Historic Review Board

April 25, 2017

HR 17-04 Public Works Operations

HR 17-03 Grainger Home

3 Elevation Rear - Proposed
A3.1 - 1/4" = 1'-0"

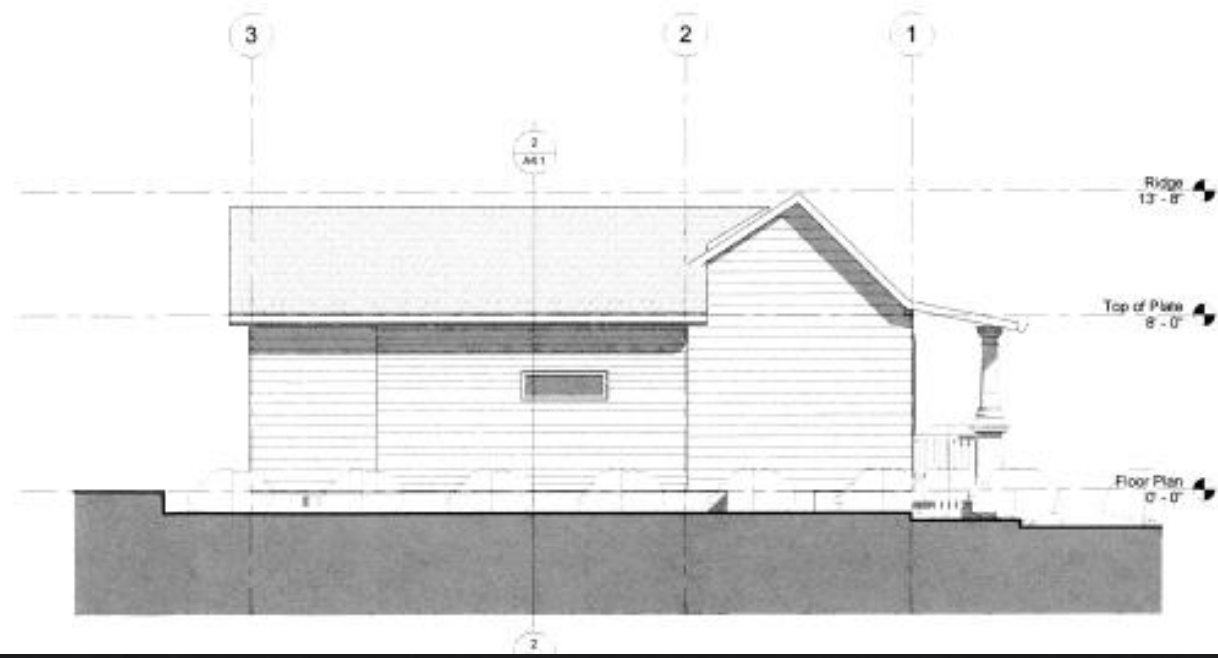
- ◇ iv. Simple vernacular styled lighting.(P)
- ◇ 2. Prior to receiving building permits, the applicant shall revised the interior side (north elevation) windows to provide a 1/1 window that matches the existing 1/1 widows on the building. (P)

- ◇ 4. Prior to receiving building permits, the applicant shall revise the front porch details to conform to the simple architectural nature of the house. (P)

- ◇ a. Porch post revised to be simple thin squared posts.
 - ◇ b. Railings are not allowed unless required by building code. If required, railing shall be simple top and bottom mounted.

- ◇ c. Simple porch lighting. Colonial or bungalow lighting is not allowed.
